Docket No. 50-247

The staff has completed its review of your evaluation of the design differences. We find your design acceptable. The enclosed SER documents the basis for those items that required additional information during our review.

UPDATED EVALUATION OF DIFFERENCES BETWEEN INDIAN POINT UNITS 2 AND 3

FIGURE # 1 A
 SIMPLIFIED DIAGRAM OF DESIGN DIFFERENCES OF THE 480VOLT
 AC DISTRIBUTION SYSTEM BETWEEN INDIAN POINT
 UNITS 2 AND 3

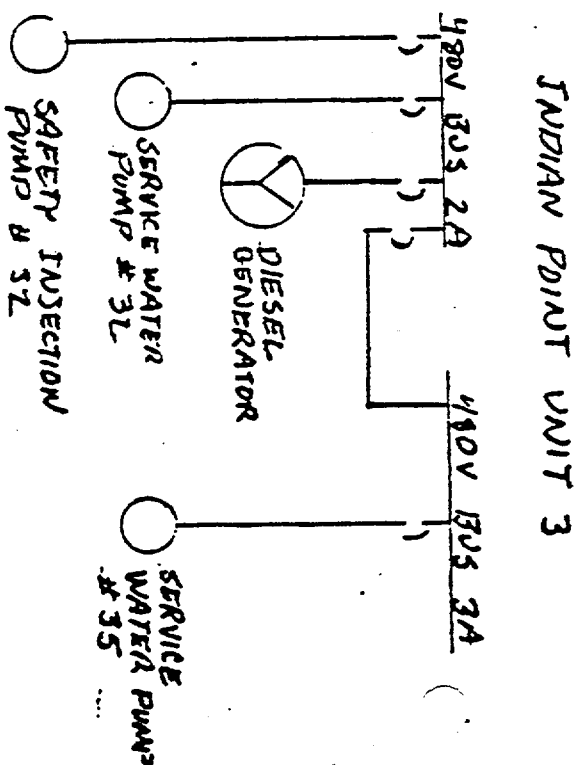
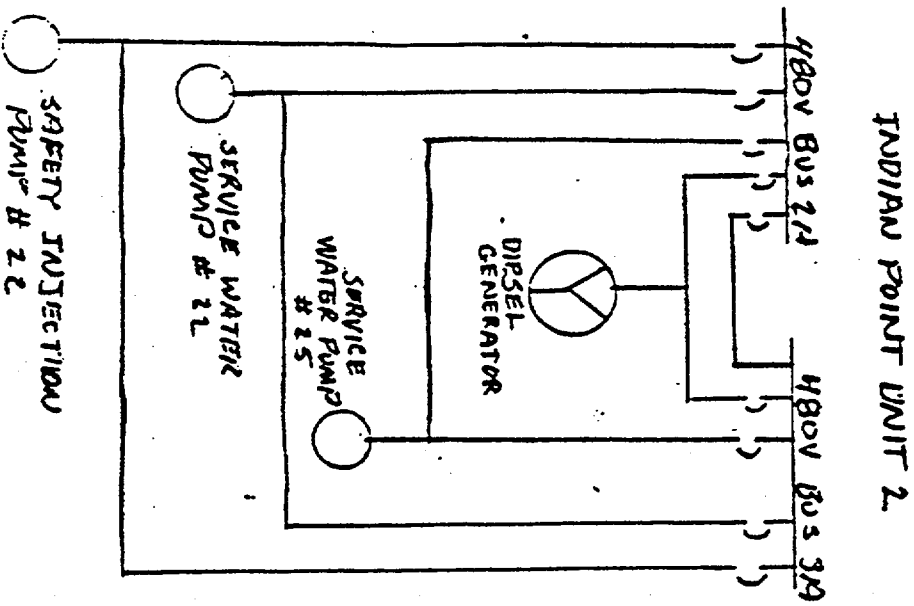
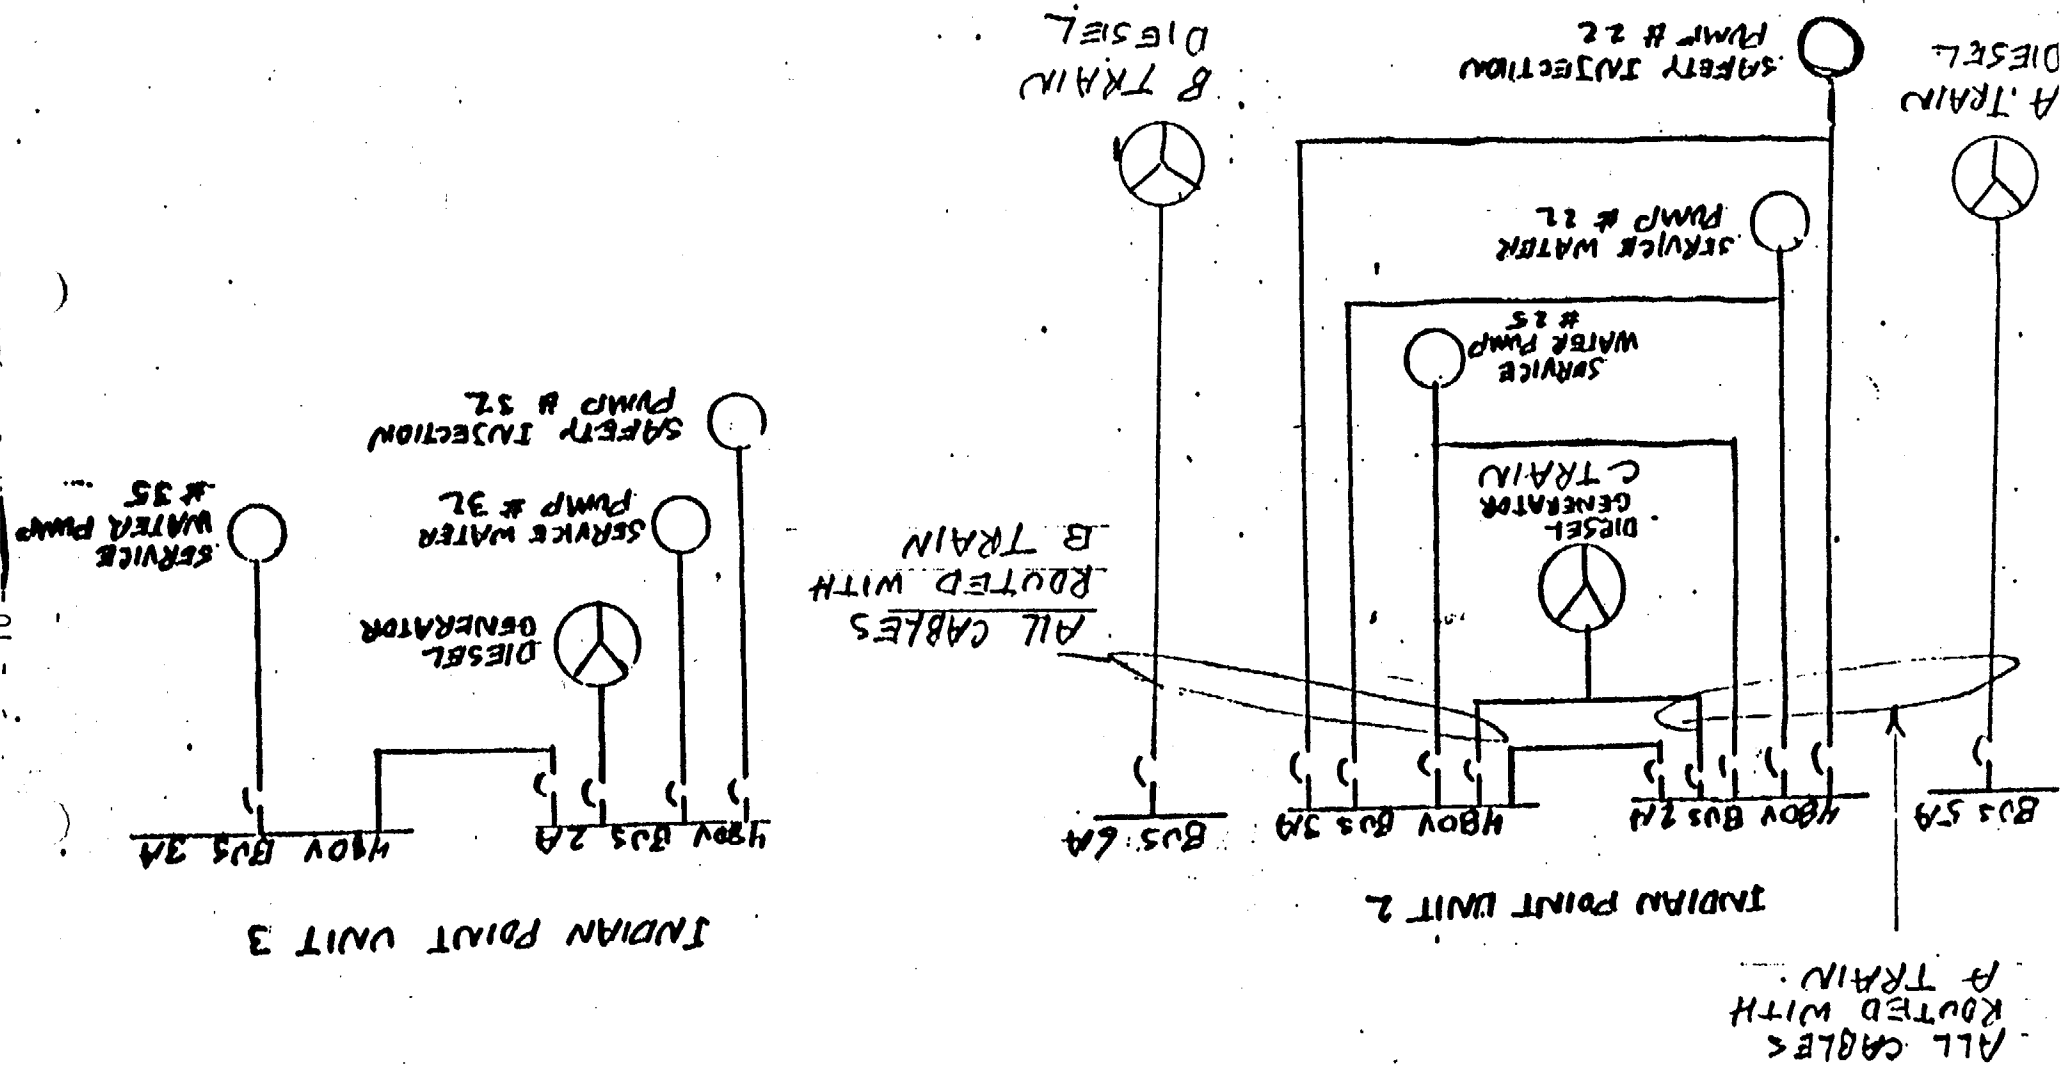
At Unit 2, it was unclear as to the number of raceway systems provided to maintain channel separation. The licensee has documented that "separation is provided on a function by function basis. There is a minimum two channel raceway throughout with a third or fourth raceway provided at points where required." In addition, our Fire Protection

Safety Evaluation Report has documented that "the reactor protection and engineered safety system cable circuits are divided into as many channels as is required to preserve the basic redundancy and independence of the systems." Based on this documented information, it appears that only two separate raceway systems are provided at Unit 2 for the three engineered safeguards channels while Unit 3 has three separate raceway systems, one for each channel.

Subsequently by letter dated May 27, 1982, the licensee further described the cable routing at Indian Point Unit 2. Figure 1 (of our October 21, 1981 evaluation of the differences identified between Units 2 and 3) has been revised (Figure 1A) to describe the routing of cables at Unit 2. Based on a review of the described routing, the staff concludes that while a single failure of a raceway or cable may cause failure of the A and C division or the B and C division, one division of three will remain for safe shutdown.

In addition an alternate safe shutdown system is presently installed at Unit 2 for fire protection. This alternate shutdown system will be further upgraded as a result of plant modifications to meet the requirements of Appendix R of 10 CFR 50. If this Appendix R review identifies areas where all three cable routing divisions can be disabled, adequate alternate shutdown measures will be required.

FIGURE 4
SIMPLIFIED DIAGRAM OF INDIAN POINT UNIT 2 PROPOSED 125V DC DISTRIBUTION SYSTEM

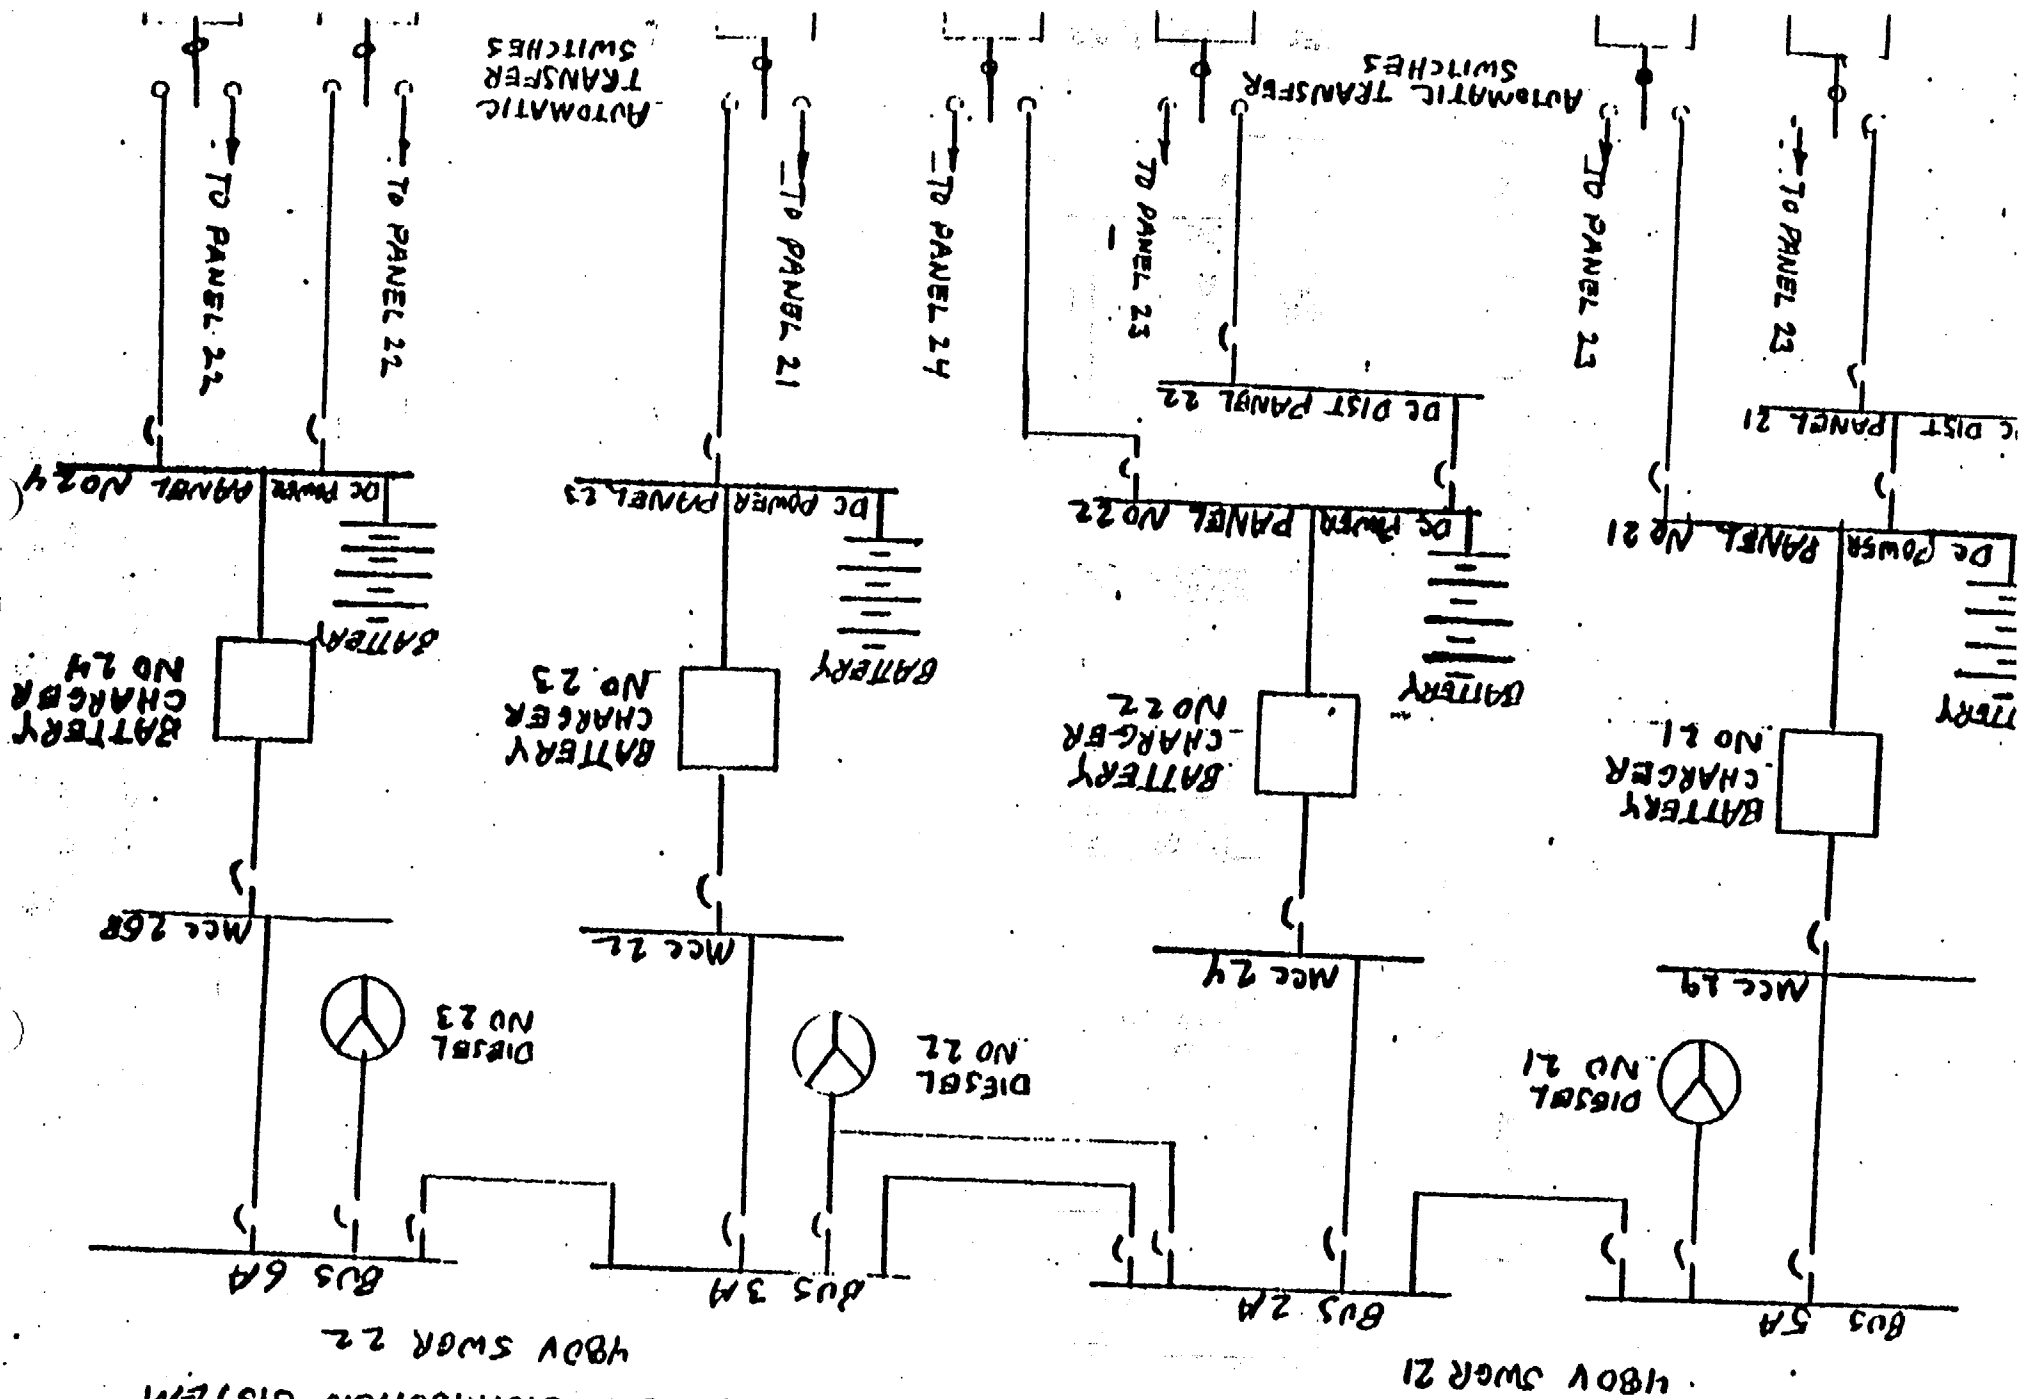
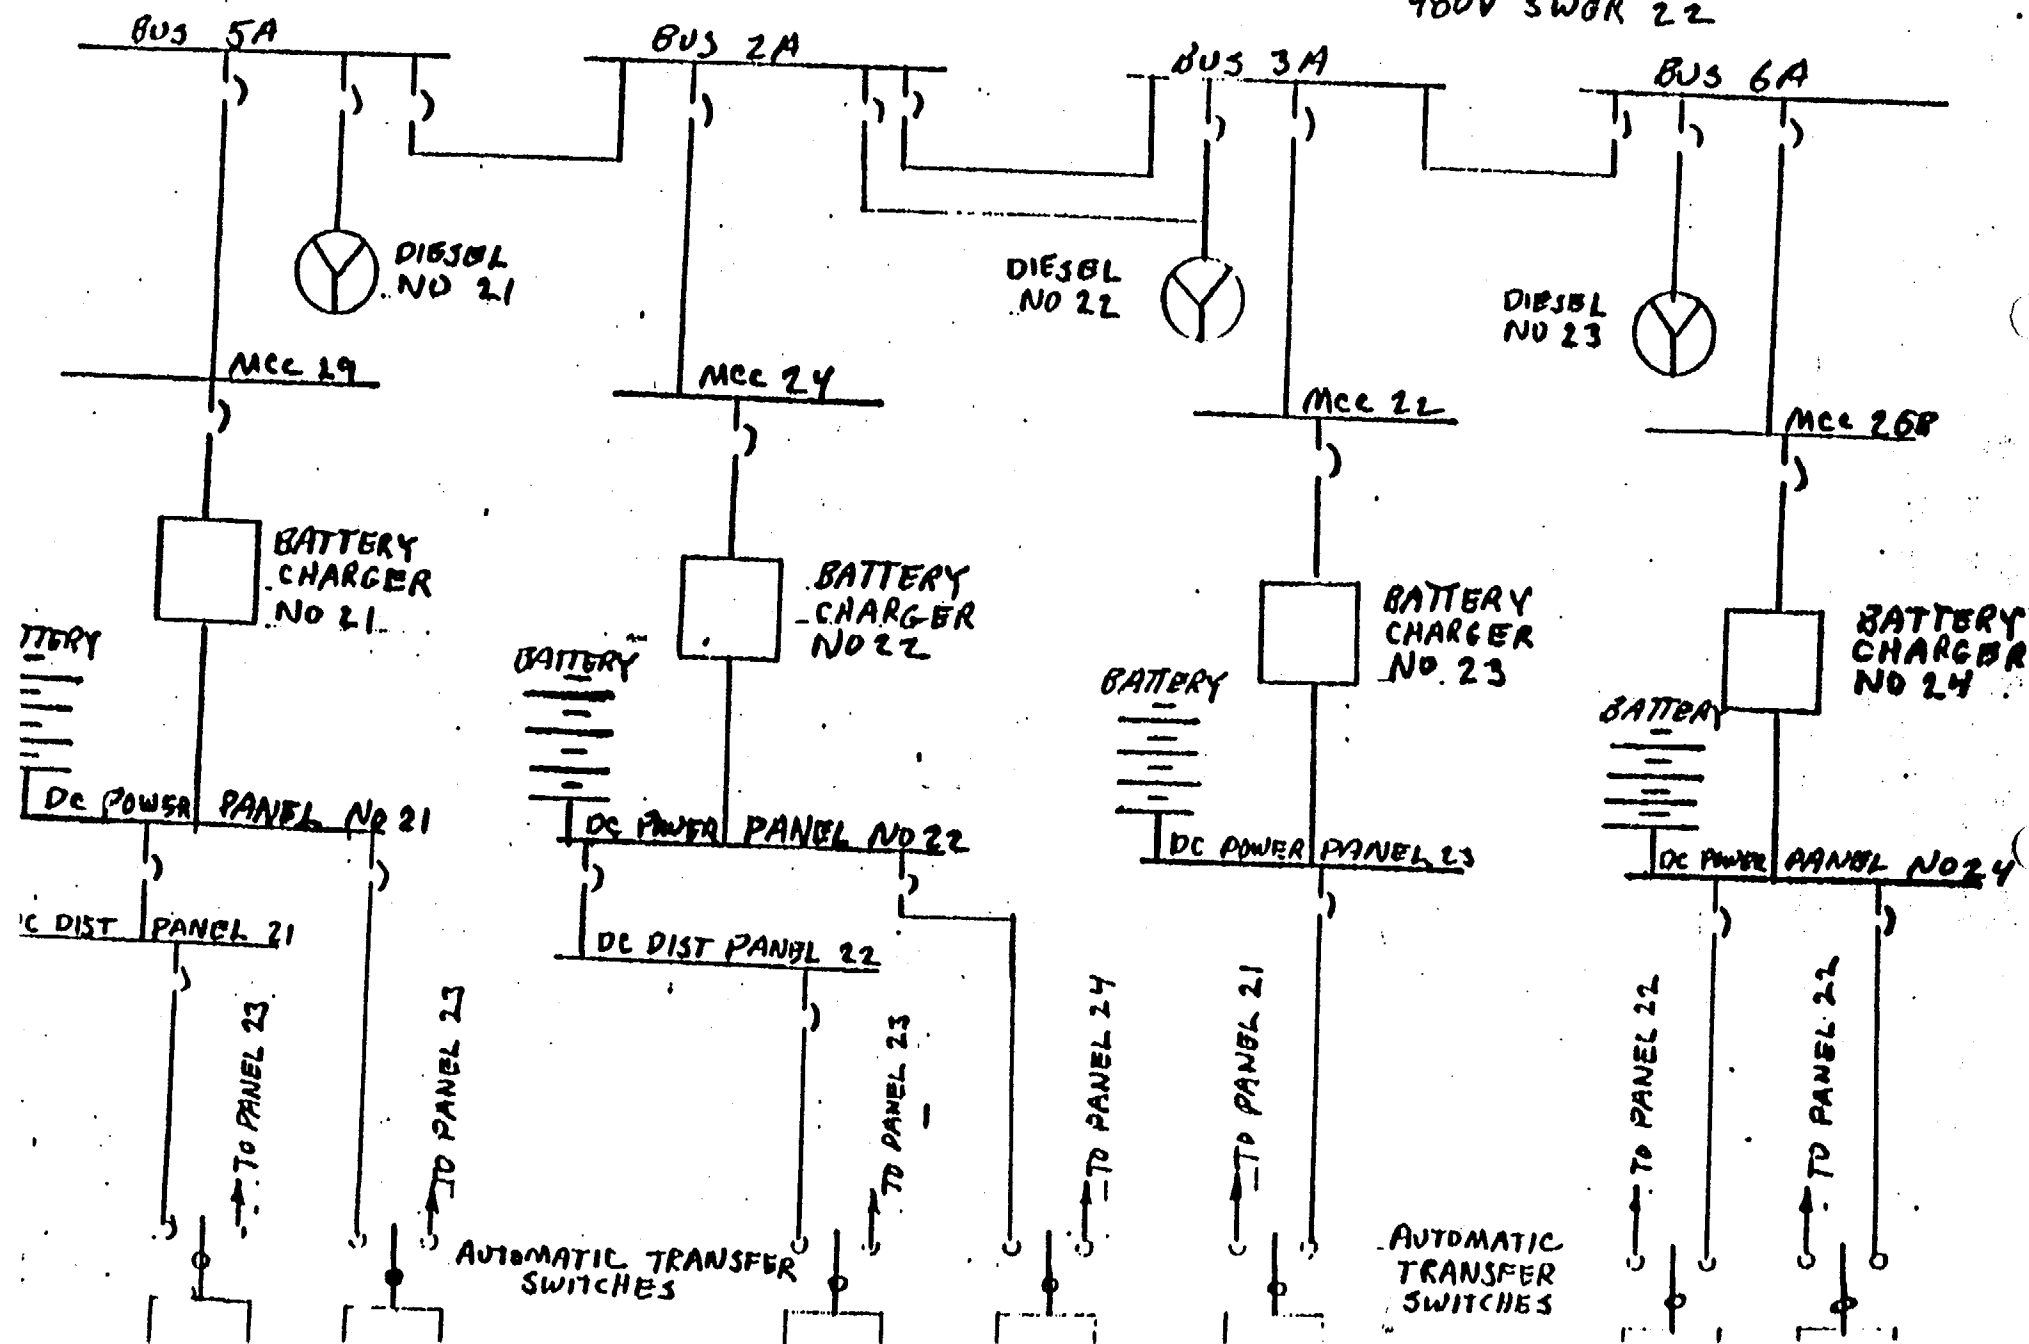
With implementation of the proposed modification to the Unit 2 125 volt DC system shown in Figure 4, a difference remains between Unit 2 and 3. Diesel generator and 480 volt switchgear control power loads for Unit 2 are automatically transferred between redundant power sources. In justification of this difference, the licensee has indicated that both Unit 3 and the proposed Unit 2 design satisfy the requirements of Regulatory Guide 1.6.

Based on our review of both Unit 2 and Unit 3 designs, we agree with the licensee's justification in regard to Unit 3 but must examine more closely for Unit 2 the position D.4.c of Regulatory Guide 1.6 which states: "No provisions should exist for automatically transferring loads between redundant power sources." The proposed Unit 2 design makes provision for automatically transferring loads between redundant power sources as shown in Figure 4.

A single failure of the automatic transfer function could cause the loss of a diesel generator and a 480V safeguards bus. However, this is essentially the same result for a single failure without automatic transfer. Thus, the alternate design for Unit 2 is acceptable, since the worst case single failure yields the same result in both designs.
